UNITED STATES
NUCLEAR REGULATORY COMMISSION
WASHINGTON, D. C. 20555

SUBJECT: MAINE YANKEE NUCLEAR POWER PLANT SEISMIC REANALYSIS
GROUND MOTION

Maine Yankee Nuclear Power Station Seismic Reanalysis Ground Motion

FIGURE 1. LLNL magnitude 5.8 SEP SSRS 50th and 84th percentile spectra, and 0.18 g NUREG/CR-0098 50th percentile amplification factors spectrum.

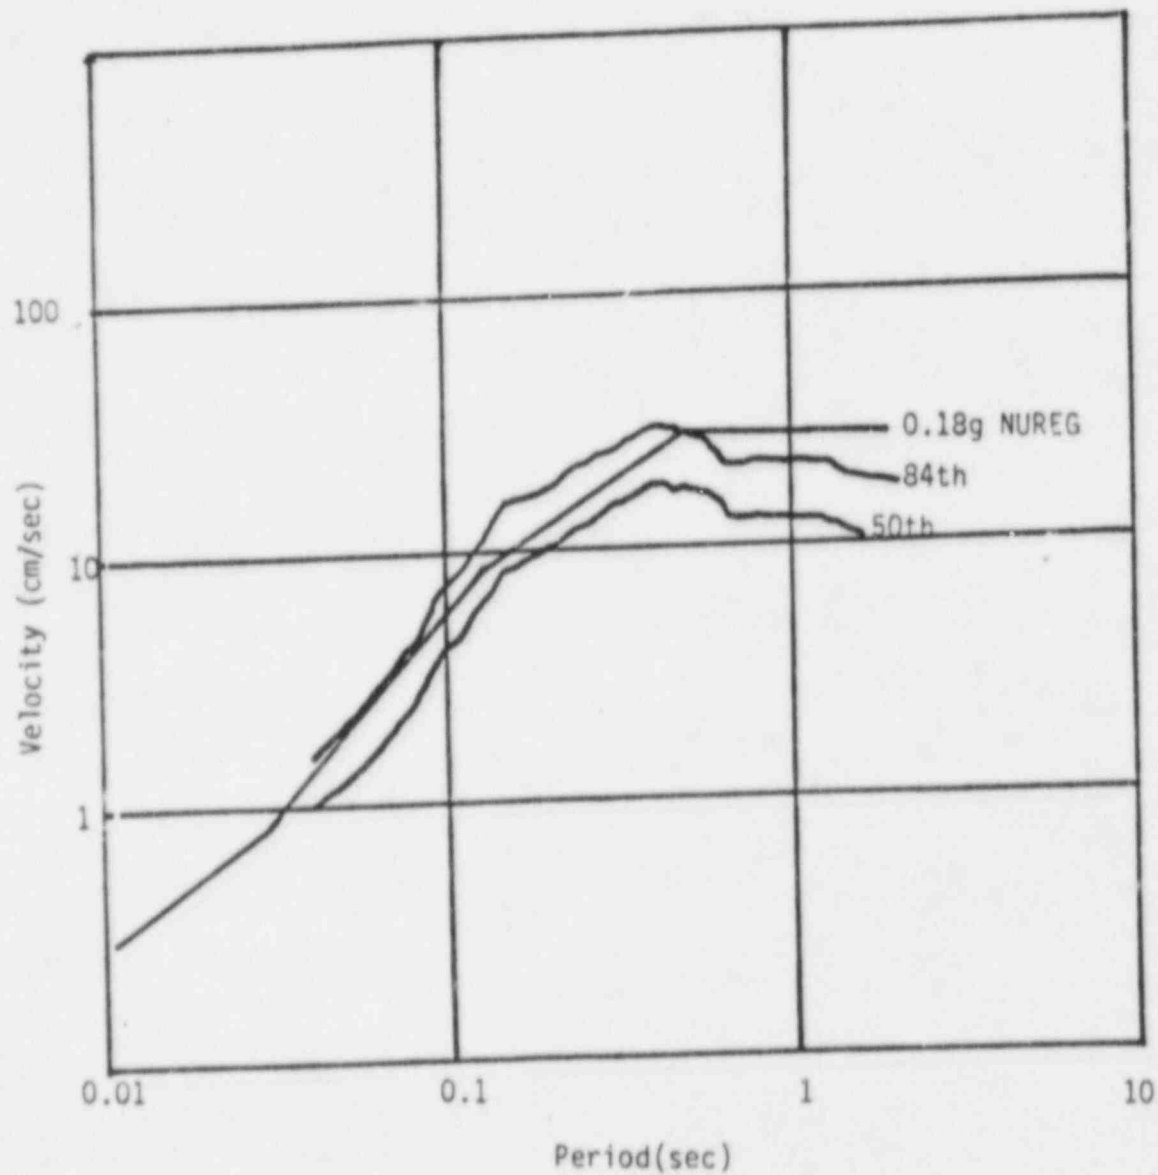
Two types of comparisons were performed, deterministic and probabilistic. Deterministic comparisons are shown in Figures 1, 2, 3 and 4. These are plots of the 50th and 84th percentile spectral levels of the LLNL magnitude 5.8 SEP site specific spectrum, the TVA magnitude 5.8 Sequoyah site specific spectrum, the WGC magnitude 5.8 Seabrook site specific spectrum and the LLNL magnitude 6.0 Seabrook site specific spectrum, respectively. Each figure also contains the 0.18g NUREG spectrum for comparison. For the three magnitude 5.8 SSRS (Figures 1, 2, 3) the 0.18g NUREG spectrum exceeds the 84th percentile SSRS at longer periods and is exceeded by the 84th percentile at shorter periods. The 84th percentile of the magnitude 6.0 SSRS essentially exceeds the 0.18g NUREG spectrum at all periods. In all cases the 0.18g NUREG spectrum exceeds the 50th percentile SSRS.

Figure 5. Ratios of design basis spectrum to LLNL (NUREG/CR-3756) 50th percentile 1000 year probabilistic spectrum for each of ten eastern U.S. sites and the ratio of 0.18g NUREG/CR-0098 50th percentile spectrum to the 50th percentile 1000 year spectrum for Maine Yankee.

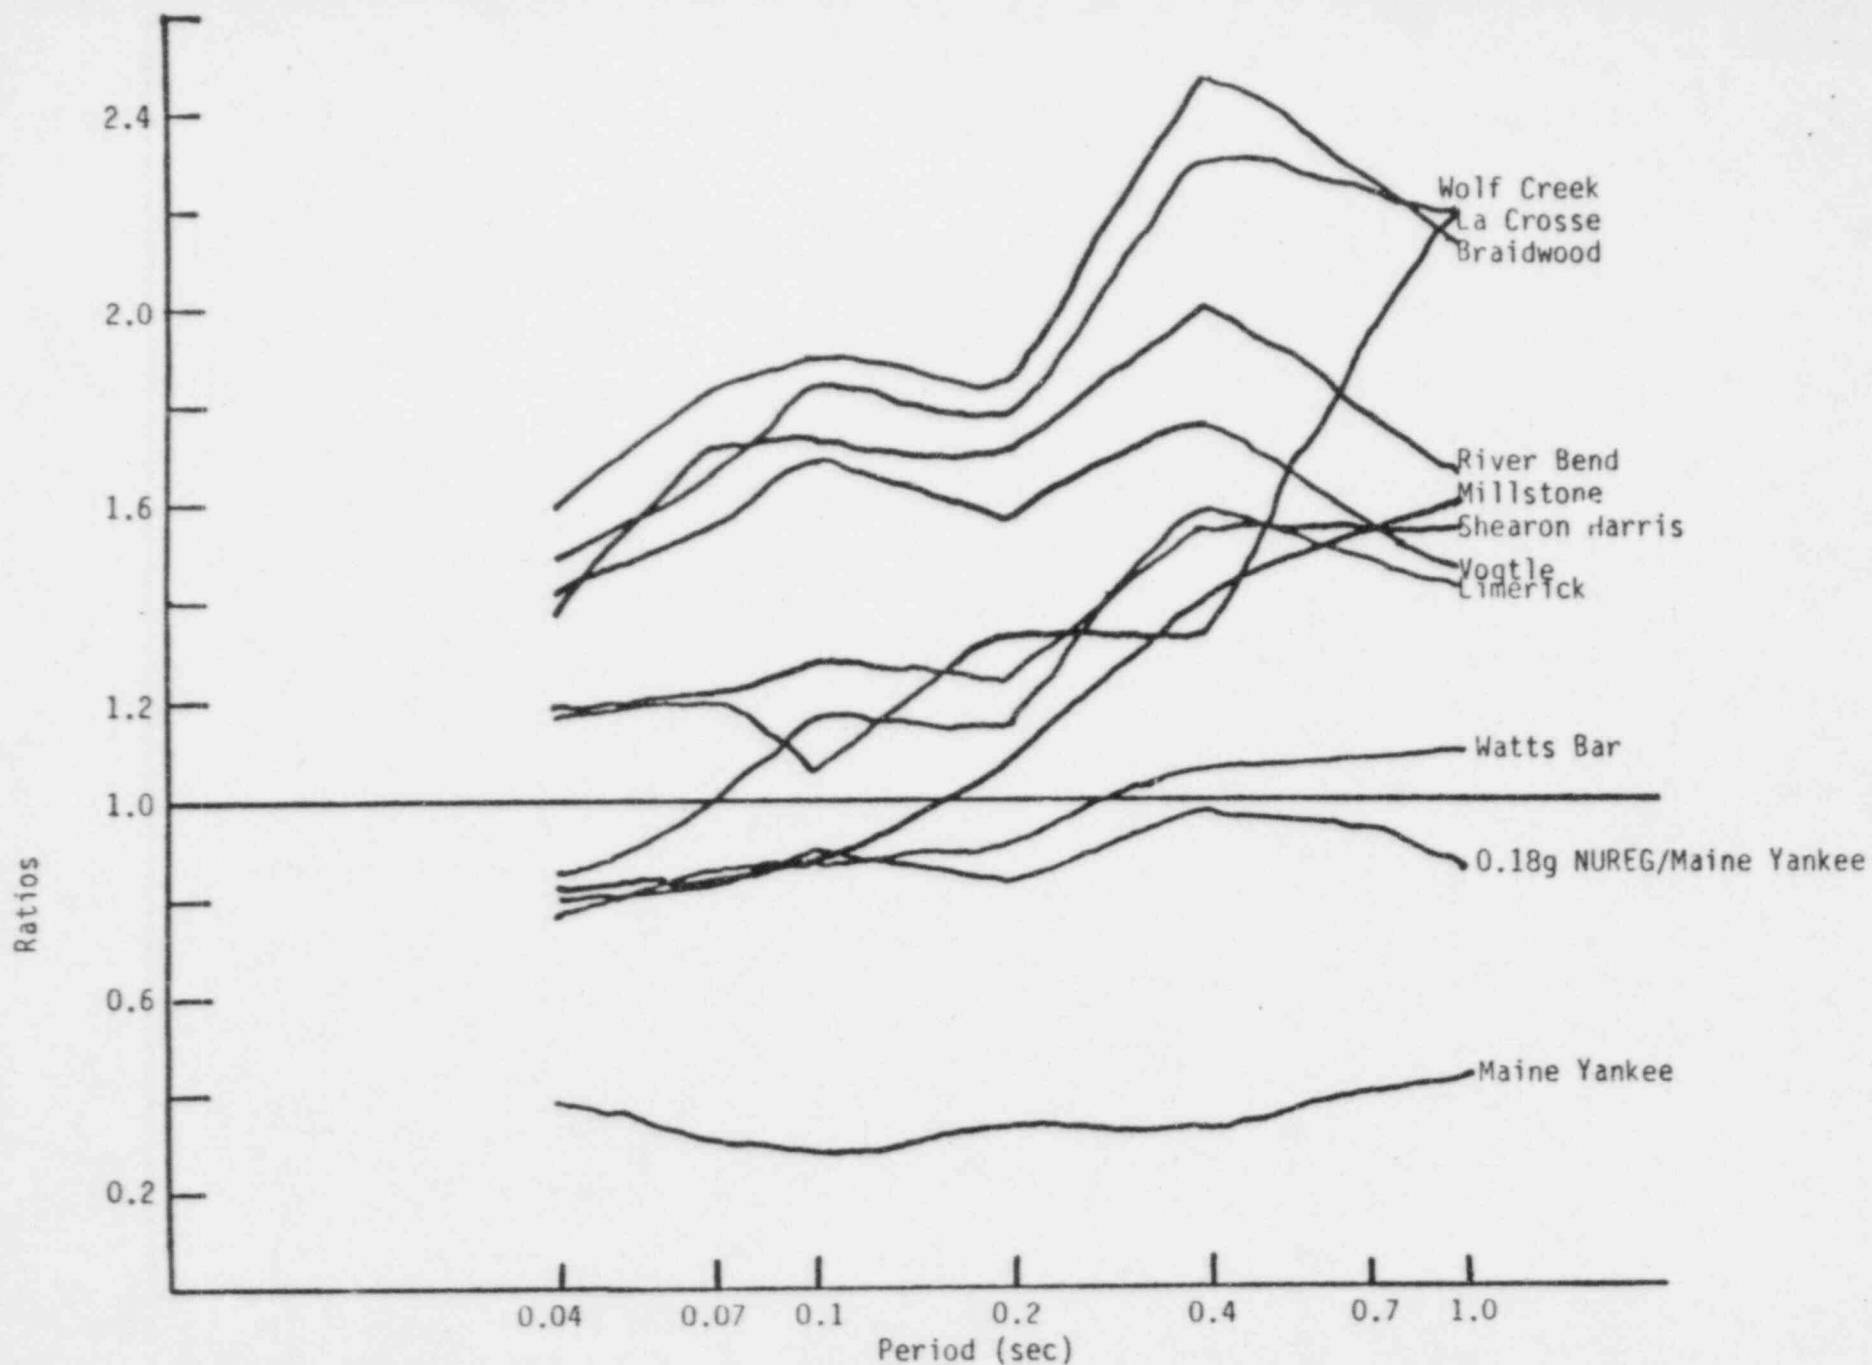
Maine Yankee is among the first ten sites evaluated under the LLNL project. In making comparisons of the seismic design bases of these ten sites to the initial probabilistic earthquake hazard calculated by LLNL (NUREG/CR-3756) we find that for Maine Yankee the ratio of the design basis (0.1g Housner) to the probabilistic hazard is significantly lower than those of the other nine sites. The probabilistic earthquake hazard representation used in the comparisons, the 50th percentile 1000 year return period, was selected because this representation is common to both the LLNL study and the licensee study and was a reference level used in the SEP spectra. The spectra called 1000 year return period may not actually represent that absolute level. They may represent longer or shorter return periods because of the uncertainties in the probabilistic methods. However, they should be relatively consistent from site to site. Figure 5 contains plots of the ratios of the design spectrum to the LLNL 50th percentile 1000 year probabilistic spectrum for each of the ten sites and also the ratio of the 0.18g NUREG response spectrum to the 50th percentile 1000 LLNL spectrum for Maine Yankee. The ratio of the Maine Yankee design

basis spectrum to the LLNL 50th percentile 1000 year spectrum is about 0.4 in the period range 0.04 to 1 second. Three of the other sites have ratios of 0.8 to 1.0 over parts of this period range and the other six sites have ratios greater than one over the entire period range. The ratio of the 0.18g NUREG spectrum to the LLNL 50th percentile 1000 year spectrum is about 0.8 to 0.95 over the period range 0.04 to 1 second. This is thus at the low end of the range of ratios calculated for the other nine sites.

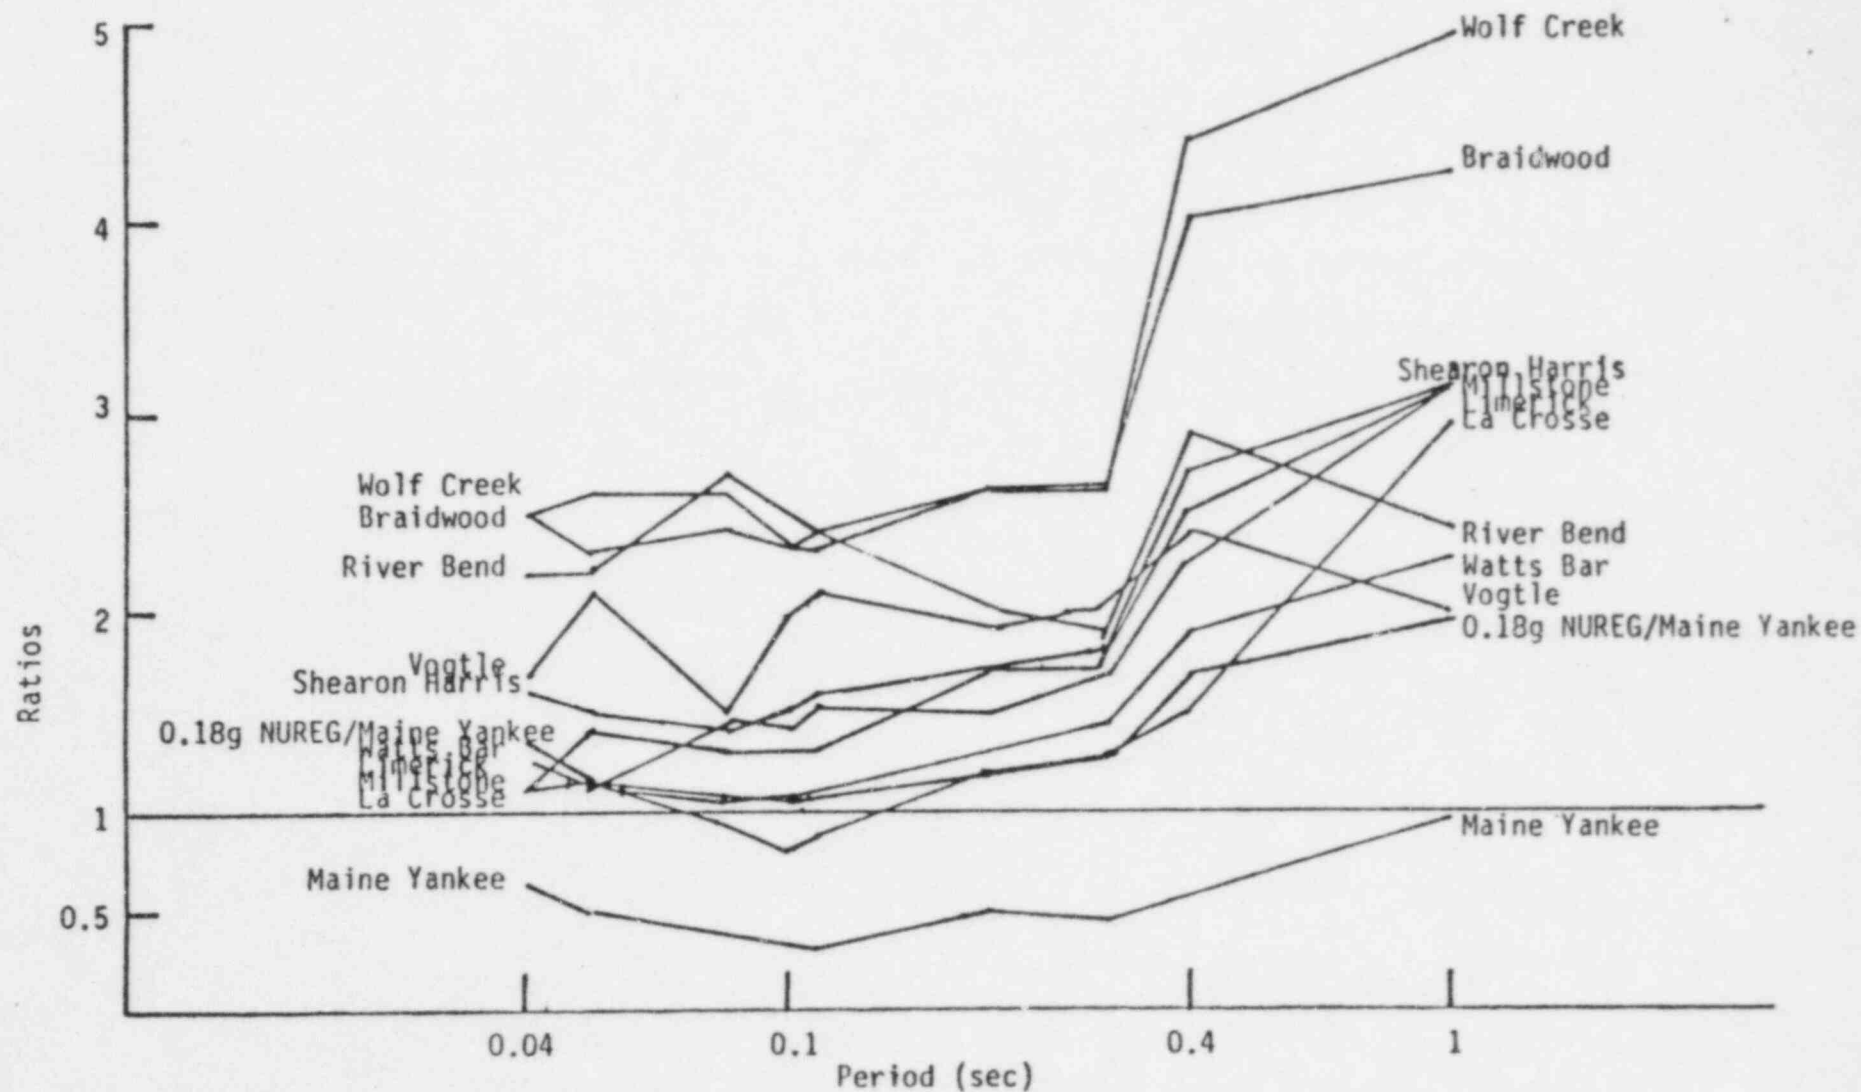
hazard among the sites has not changed significantly even though the attenuation relations, which the licensee claimed were biased, had been modified. Figure 6 contains a plot of the ratios of the design spectra to the latest LLNL 50th percentile 1000 year probabilistic spectra for each of the ten sites and also the ratio of the 0.18g NUREG response spectrum to the 50th percentile 1000 year LLNL spectrum for Maine Yankee. The ratio of the Maine Yankee design basis spectrum to the LLNL 50th percentile 1000 spectrum is still the lowest of all ten sites. The ratio of the 0.18g NUREG response spectrum to the LLNL probabilistic spectrum for Maine Yankee is about 1 or greater and at the lower end of the ratios for all ten sites. Figure 7 is a plot of the licensee's 1000 year uniform hazard spectrum for Maine Yankee and the latest LLNL 1000 year 50th percentile spectrum. These probabilistic estimates are approximately equal for periods greater than 0.35 seconds. At shorter periods the LLNL spectrum exceeds the licensee's spectrum somewhat.

FIGURE 8. Licensee's uniform hazard spectra and 0.18g NUREG/CR-0098 50th percentile amplification factors spectrum.

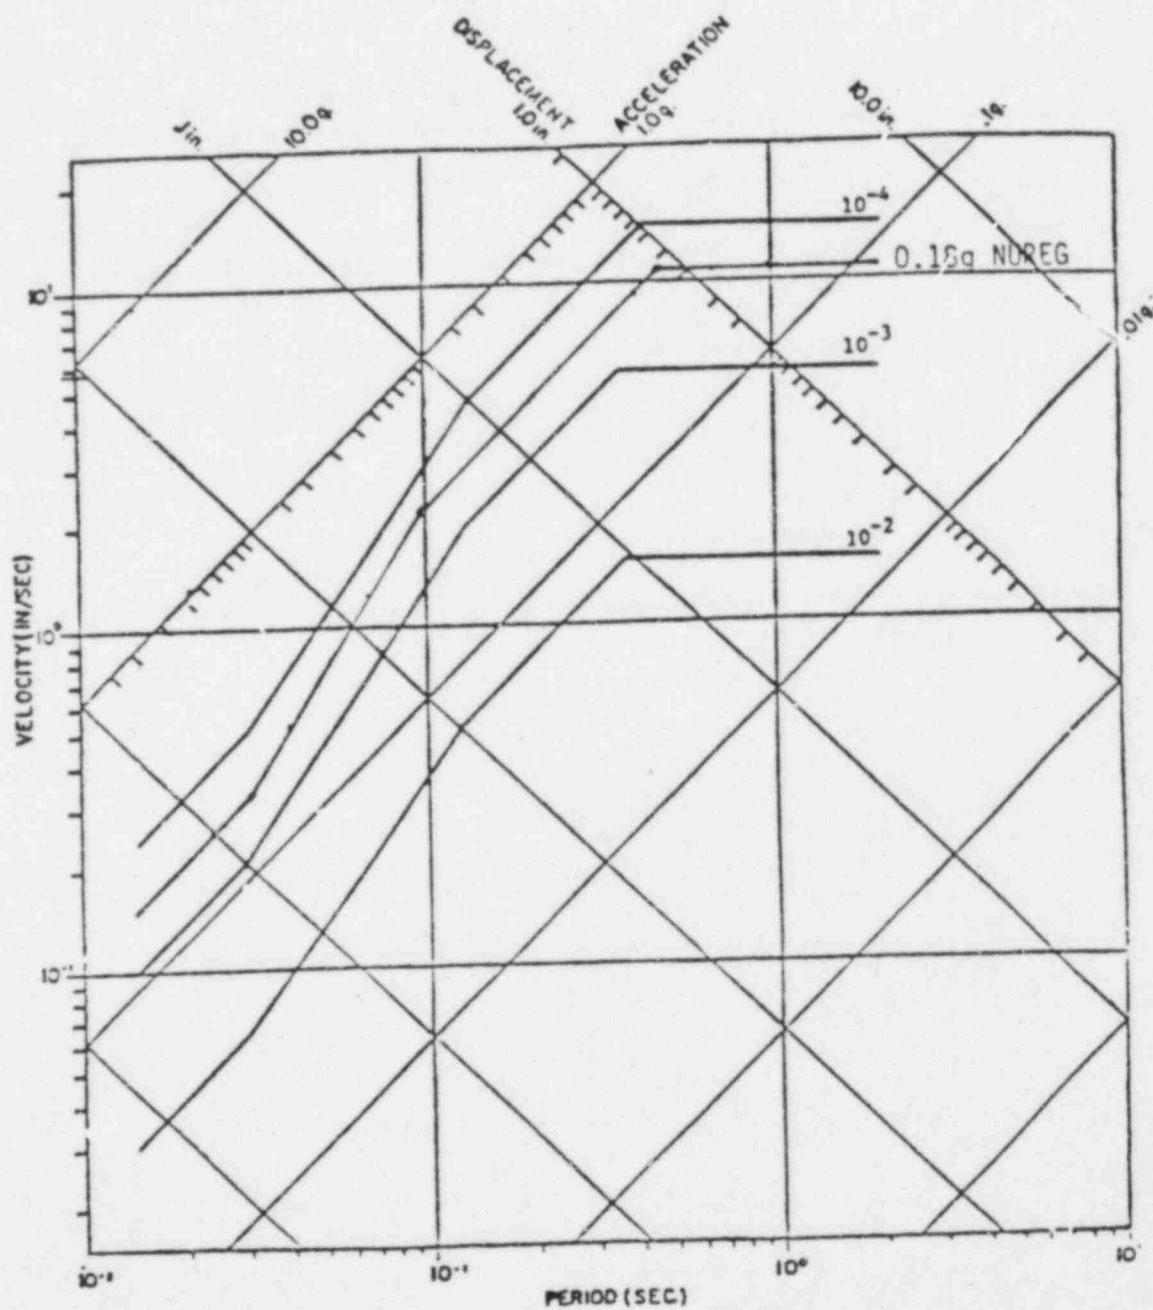
A comparison of the 0.18g NUREG spectrum with the licensee's uniform hazard spectra, Figure 8, indicates that the 0.18g NUREG spectrum would have an annual probability of exceedance between 10^{-3} and 10^{-4} . A similar comparison of the 0.18g spectrum with the latest LLNL Maine Yankee hazard spectra, Figure 9, indicates that the 0.18g NUREG spectrum would have a return period of between 1,000 and 10,000 years.
